SERVICE BULLETIN # 1165

SUBJECT CRANKCASE COVER ASSEMBLIES, P/N 57126 AND P/N 57126A

MODEL MC-1, MC-2, MC-7, 1-42, 1-45, 1-52, 1-62 DATE 3/19/62

FIGURE 1

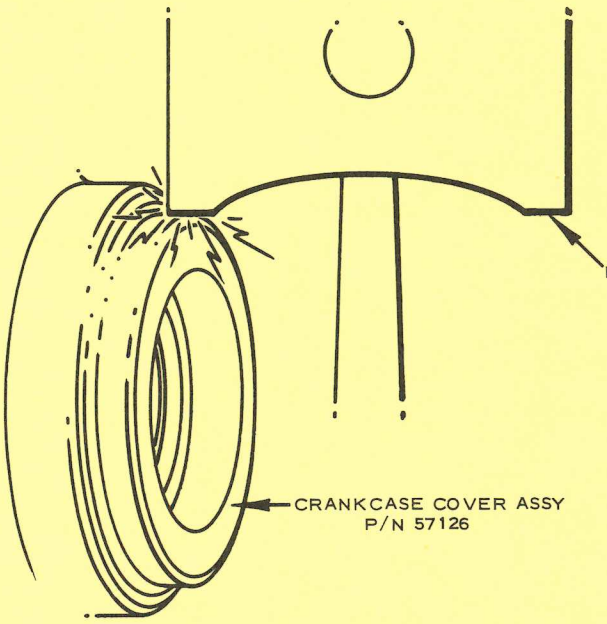
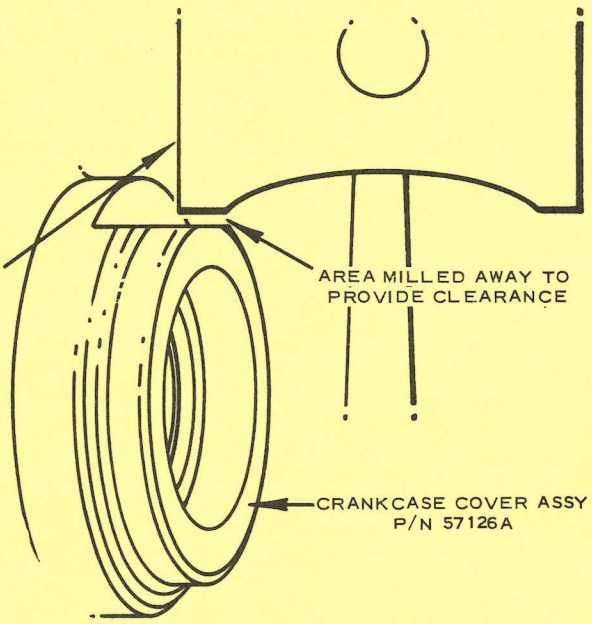
The MC-2 and MC-7 engines have a longer stroke than the other models listed. At the bottom of the stroke the piston skirt will strike on the bearing boss of the Crankcase Cover Assembly, P/N 57126 (Figure 1). As a result piston breakage and other damage to an MC-2 or MC-7 kart engine will occur.

To prevent this, a new Crankcase Cover Assembly, P/N 57126A, which has a flat spot milled on the bearing boss (Figure 2) to give the piston necessary clearance at the bottom of the stroke, is available for service replacement on the MC-2 and MC-7 kart engines.

While the new Crankcase Cover Assembly, P/N 57126A, can also be used for service replacement on the MC-1, 1-42, 1-45, 1-52, and 1-62 engines, do not attempt to use Crankcase Cover Assembly, P/N 57126, on a MC-2 or MC-7 engine.
